**DT85 Pole Guide Pin Weldment**

**Units Affected:** Certain DT85H and DT85E derricks built from November 2020 to June 2025. Verify your unit is affected by reviewing the attached list or accessing Altec Connect.

**Figure 1 — Installed Pole Guide Pin Brackets**

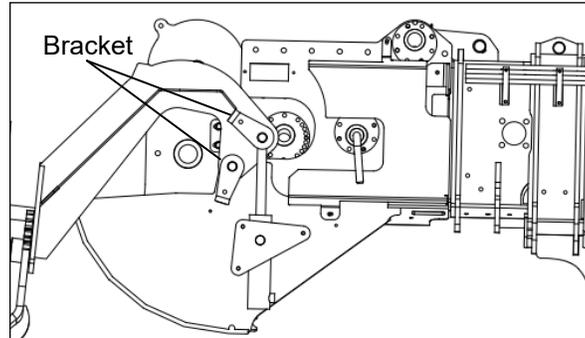
**Background:** Altec has designed new pole guide pin brackets to reinforce the pole guide assembly and help prevent fatigue and assembly damage on affected units (refer to Figure 1).

**Customer Action:** At your cost, you can order and install the Pole Guide Pin Weldment Kit, part number 992015622. Installation of this kit will reinforce the pole guide assembly and could help prevent fatigue and assembly damage.

**Requirements:** A forklift or lifting device with appropriate rigging rated for at least 2,000 lbs will be required for this repair. All welds must be applied by a welder having the AWS D1.1 3F and 4F qualification for horizontal welding on steel using one of the following approved methods.

- FCAW-G—gas shielded flux core wire (E71T-1M/9M)
- FCAW-S—gasless self-shielded flux core wire (E71T-11)
- SMAW—stick electrode (E7018 H4R)
